BAYERISCHE MOTOREN WERKE
AKTIENGESELLSCHAFT

Rundschreiben der Abteilung Kundendienst und Teile

Motorcycles: Group ~~Suspensions and shock absorbers~~ No. 61/61 (179)

Re: Motorcycles R 50 S and R 69 S with hydraulic steering damper

Drawing

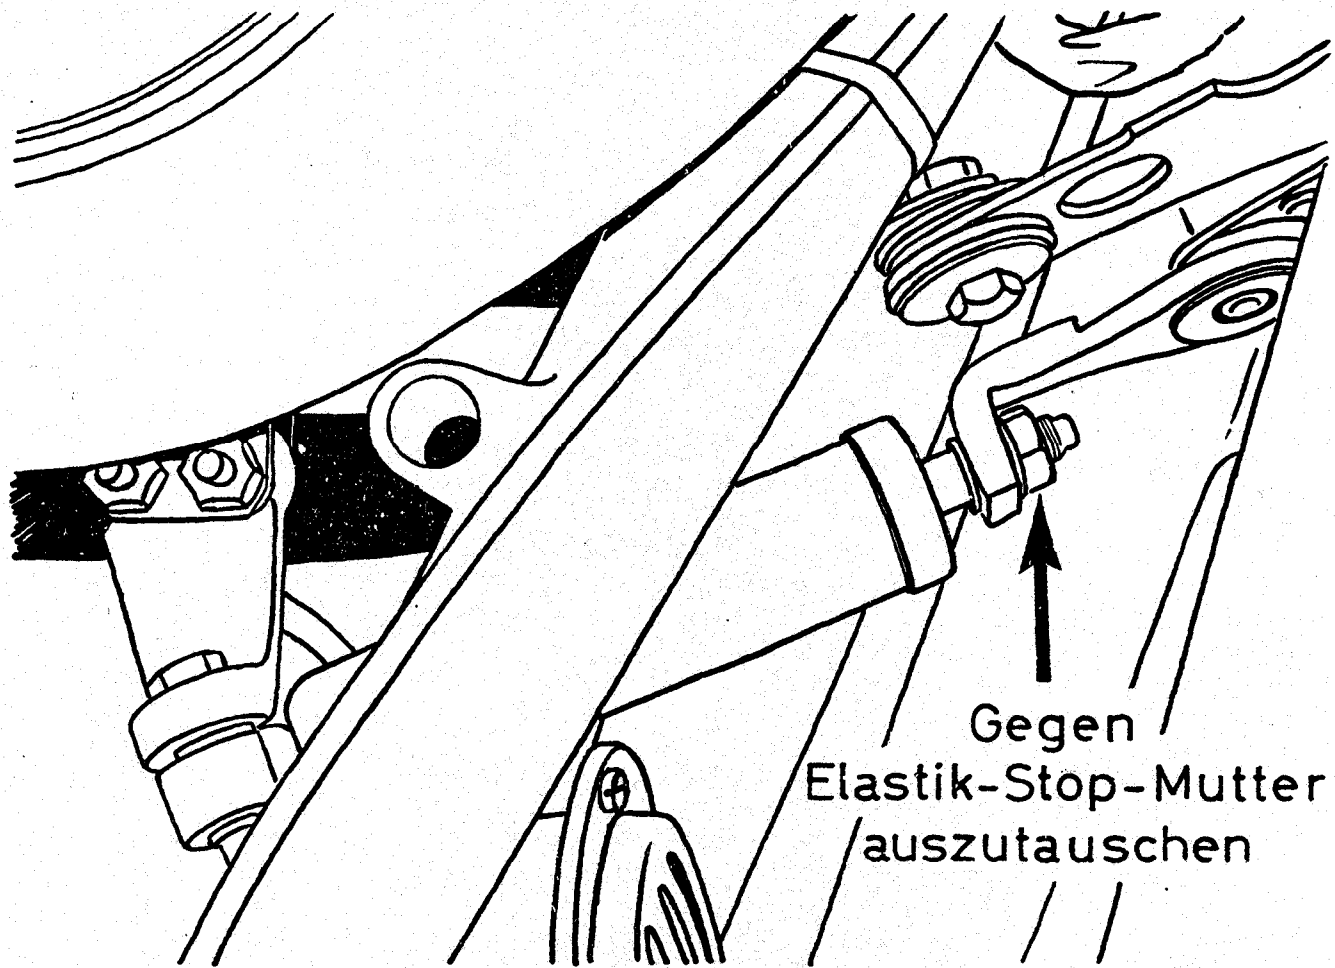
As we have learnt there is the likelihood that by inappropriate tampering with the fittings for the hydraulic steering damper on the motorcycles of the before mentioned types the nut becomes loose, with which the piston rod of the steering damper is screwed to the front fork.

From this date therefore the hitherto used normal nut has been replaced by the elastic stop nut 99 22 426 (self-locking nut).

Gegen
Elastik-Stop-Mutter
/ auszutauschen

For this we are kindly asking you to immediately replace the normal nut by the elastic stop nut on the R 50 S and R 69 S motorcycles already delivered to you.

We attach such an importance to the execution of this replacement that we request you to please report us the replacement, indicating the frame number, at your earliest convenience.
